February 8, 2023

Reference: Chapter 40B Comprehensive Permit Application  
North Bedford Crossing  
109 Bedford Street  
Lakeville, Massachusetts  
B+T Project No. 3420.01

Beals and Thomas, Inc. (B+T) is pleased to assist the Town of Lakeville Zoning Board of Appeals (the Board) with the peer review of the proposed Chapter 40B Comprehensive Permit Application for North Bedford Crossing (the Project). We understand that North Bedford Crossing, LLC (the Applicant) proposes to develop a 12-lot residential subdivision, comprised of 12 three-bedroom homes at 109 Bedford Street (the Site). The Project also consists of associated site improvements including, landscaping, utility connections, and a stormwater management system (the Project).

# Hydraulic Elements Graph

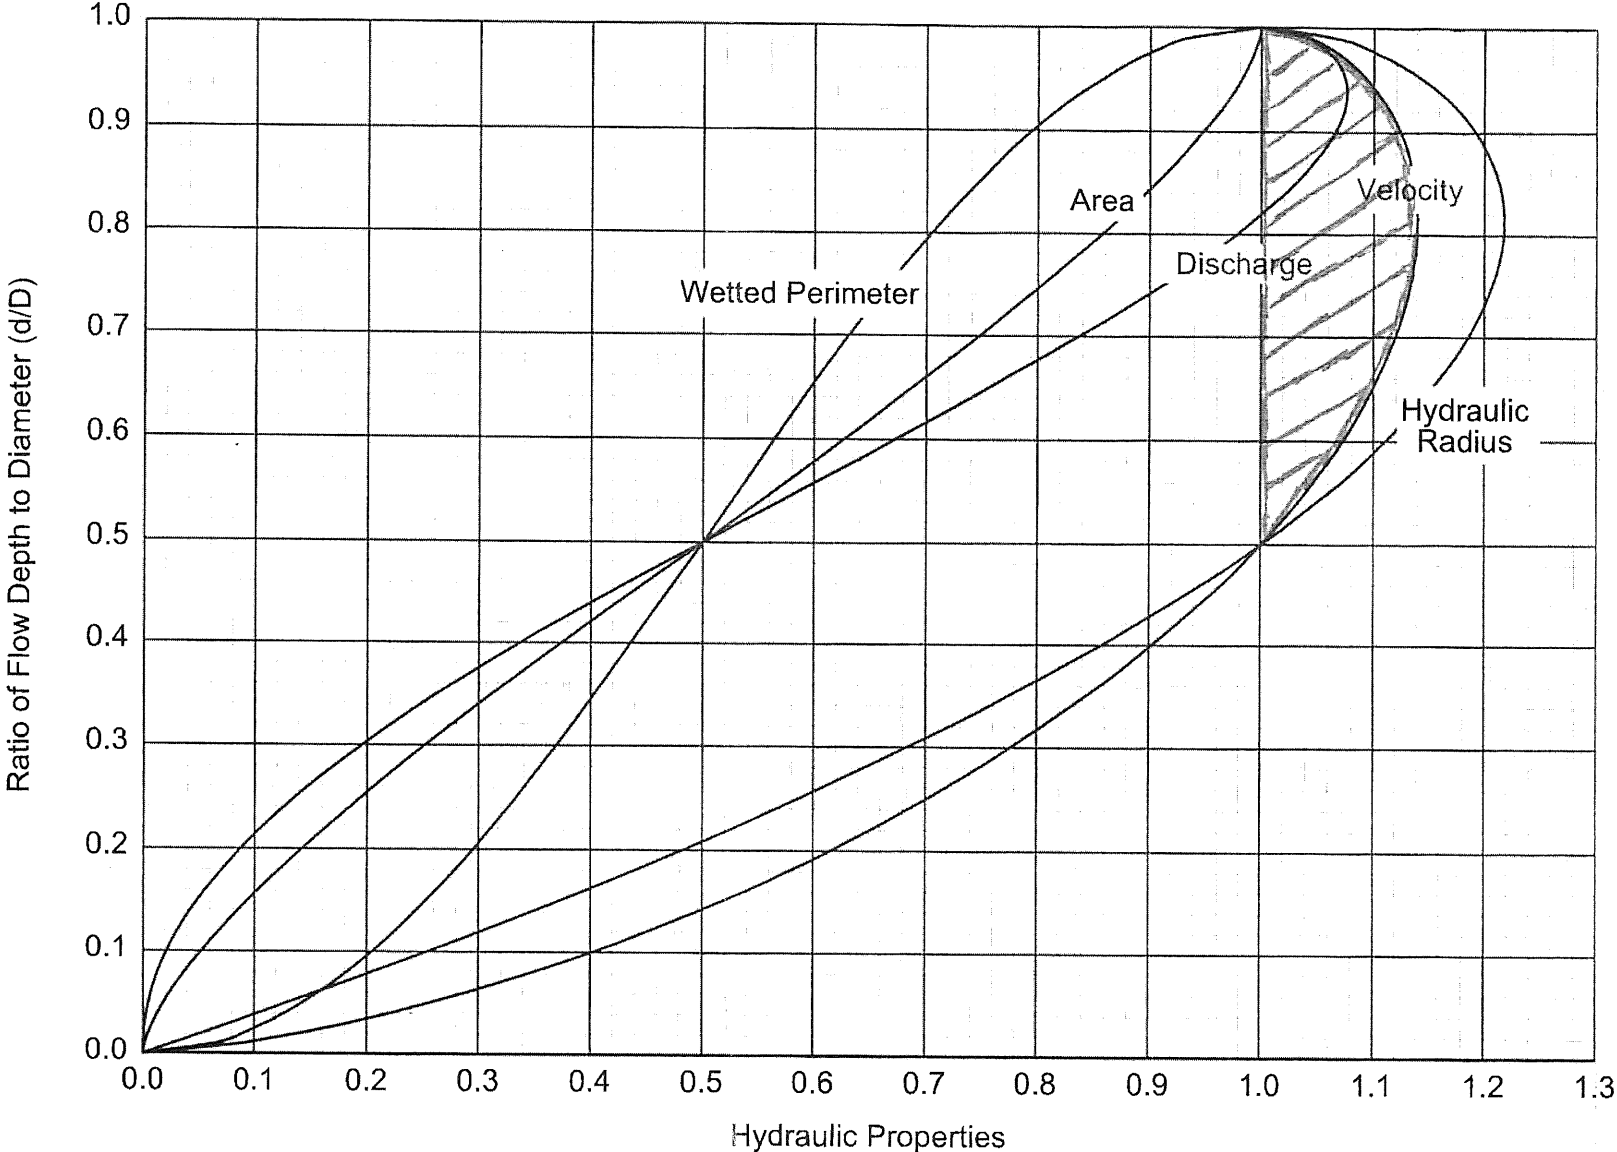
27. We acknowledge the pipe design calculations provided by the Applicant. In multiple instances, the velocity of discharge being reported is greater than the theoretical pipe flowing full velocity. We request the Applicant clarify the referenced condition and revise the calculations as may be applicable. **Response: In open channel flow conditions, all pipes flowing between half- and full-depth flow at a velocity greater than the velocity expected when flowing full. The reason for this is that there is more pipe wall friction on the fluid in the pipe-full condition. Please see the attached Hydraulic elements chart.**

**UTILITY PLAN**  
 109 BEDFORD STREET  
 LAKEVILLE, MASSACHUSETTS  
 NORTH BEDFORD CROSSING LLC,  
 1 LAKEVILLE BUSINESS PARK DRIVE  
 LAKEVILLE, MASSACHUSETTS

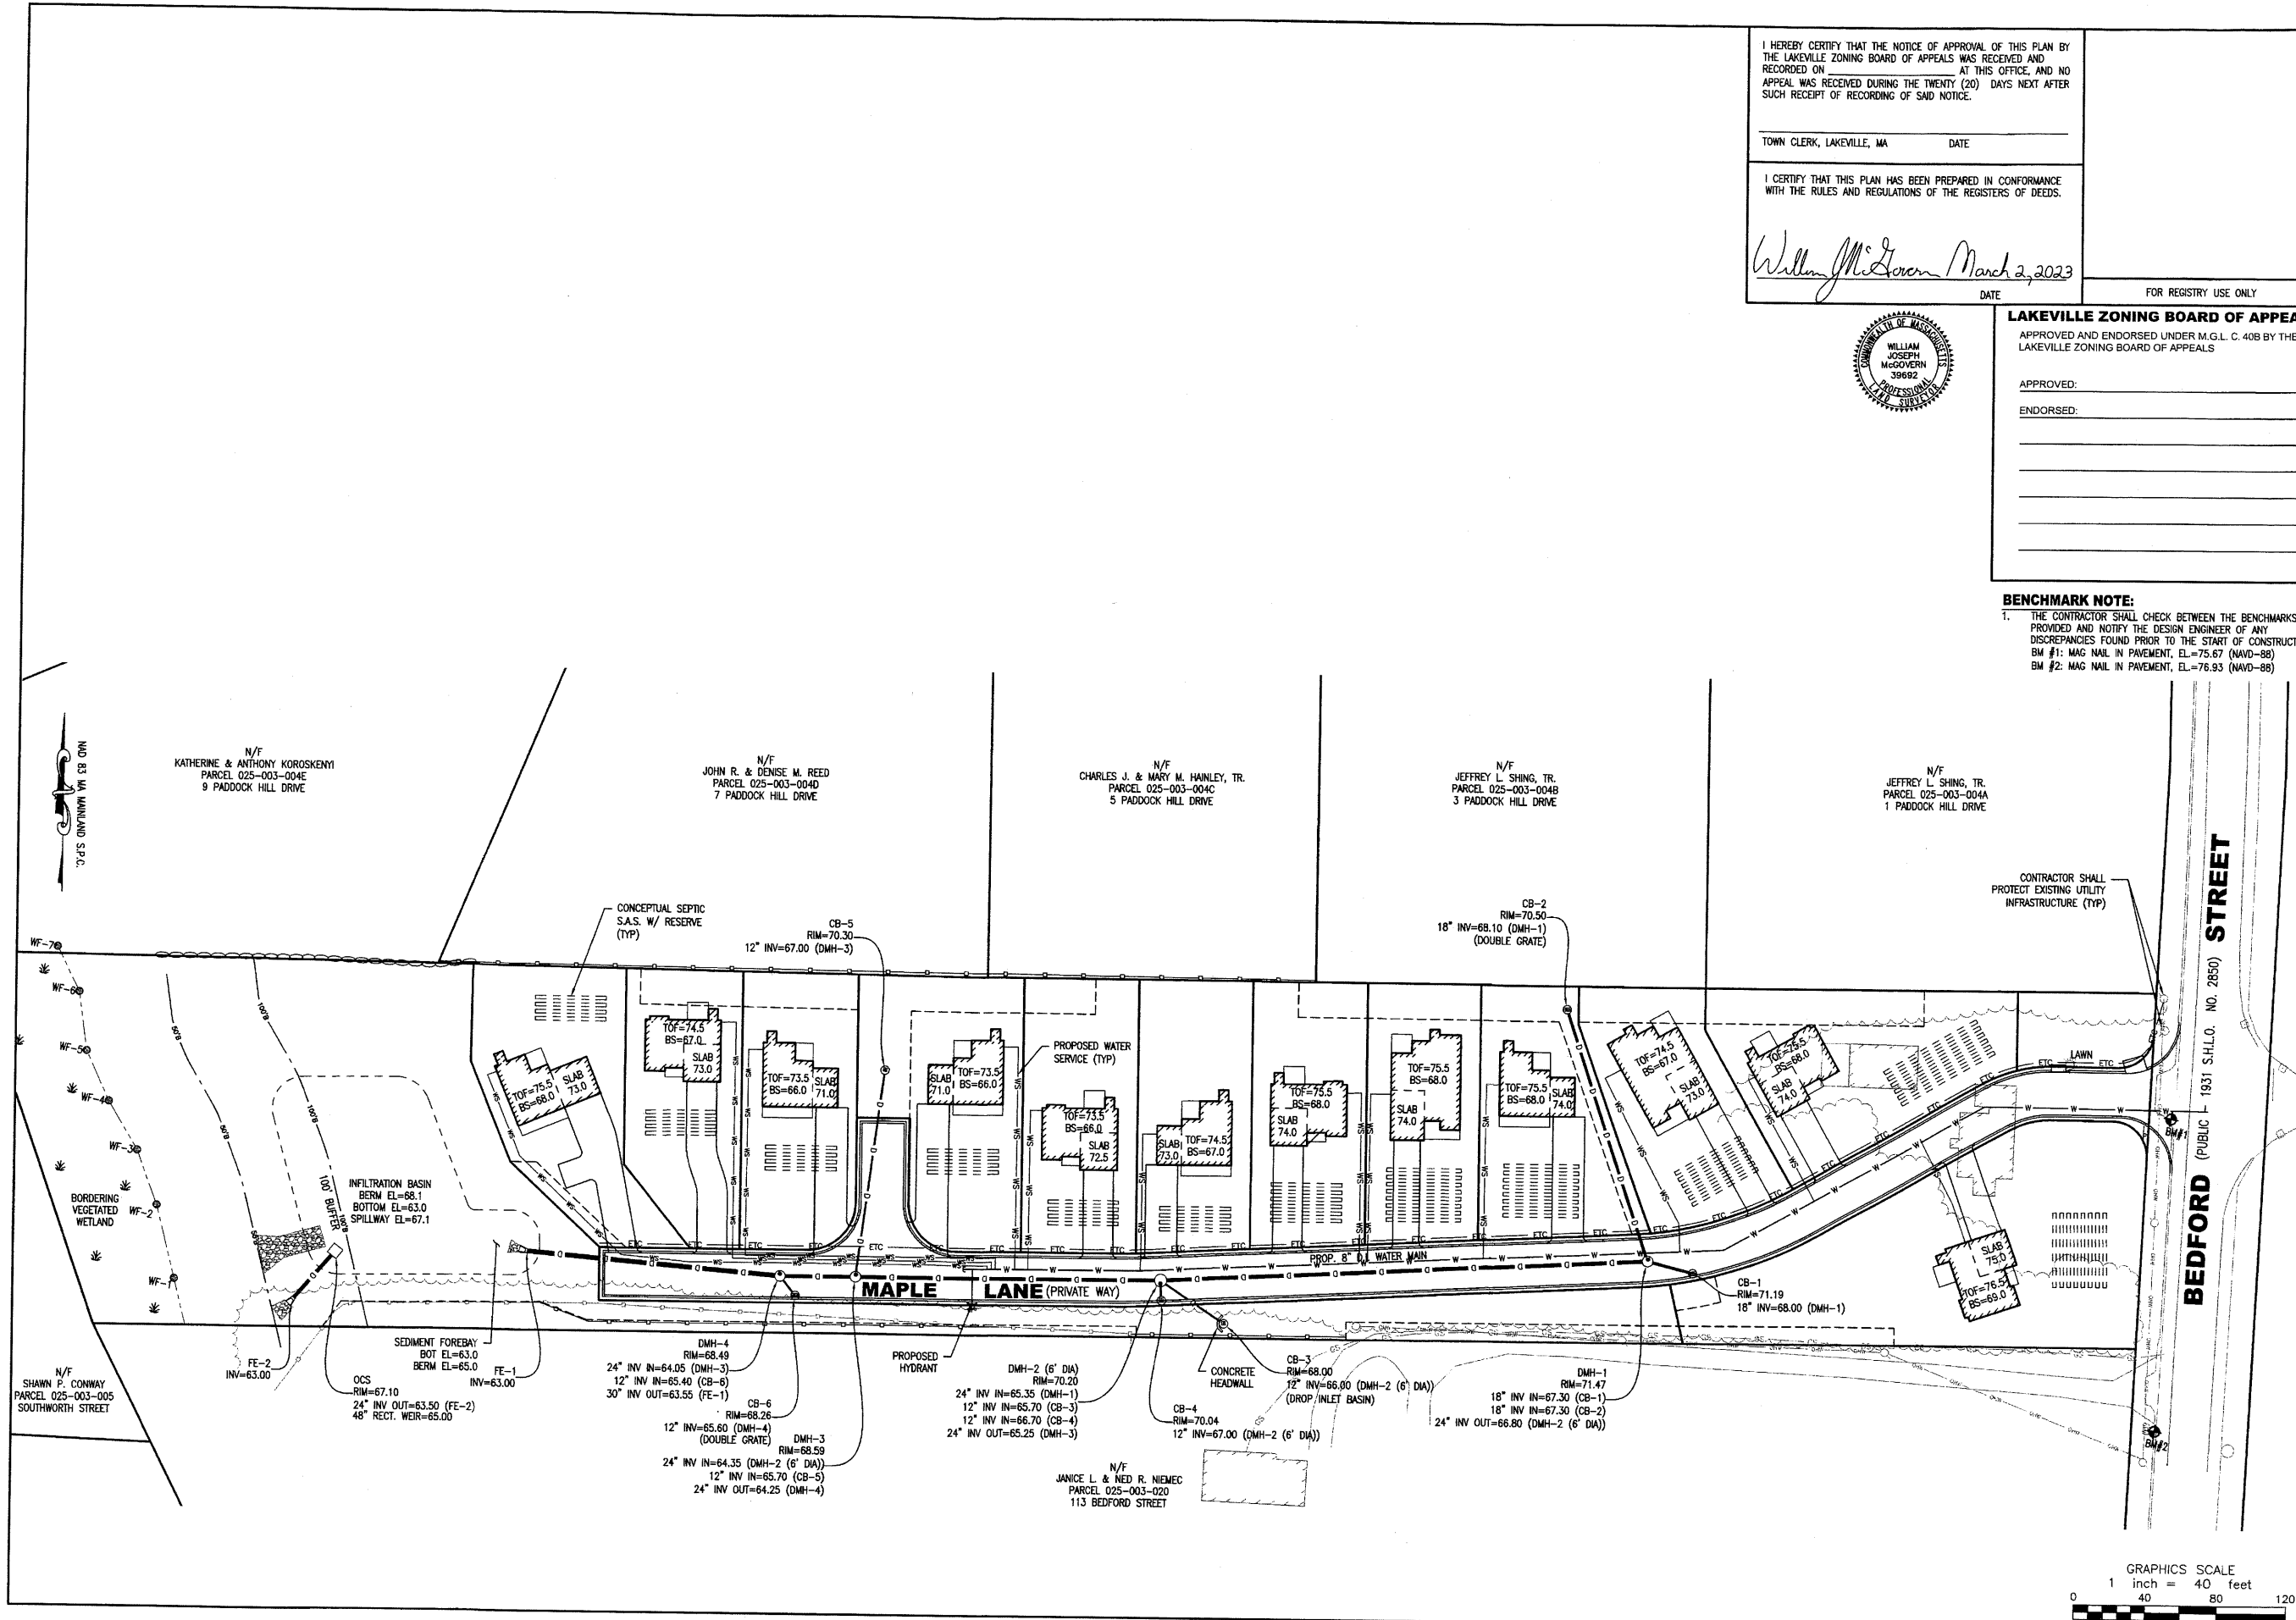
10. The Applicant has not depicted a corridor or layout for private electrical and telecommunication services. Understanding these services will need to be coordinated with the specific utility providers, we request that the Applicant provide and depict a proposed corridor for the referenced utilities. **Response: A conceptual layout for electrical and telecommunications conduits has been added to sheet G of the plans as requested. Final locations and routing of these services and any associated easements shall be determined by the utility companies.**
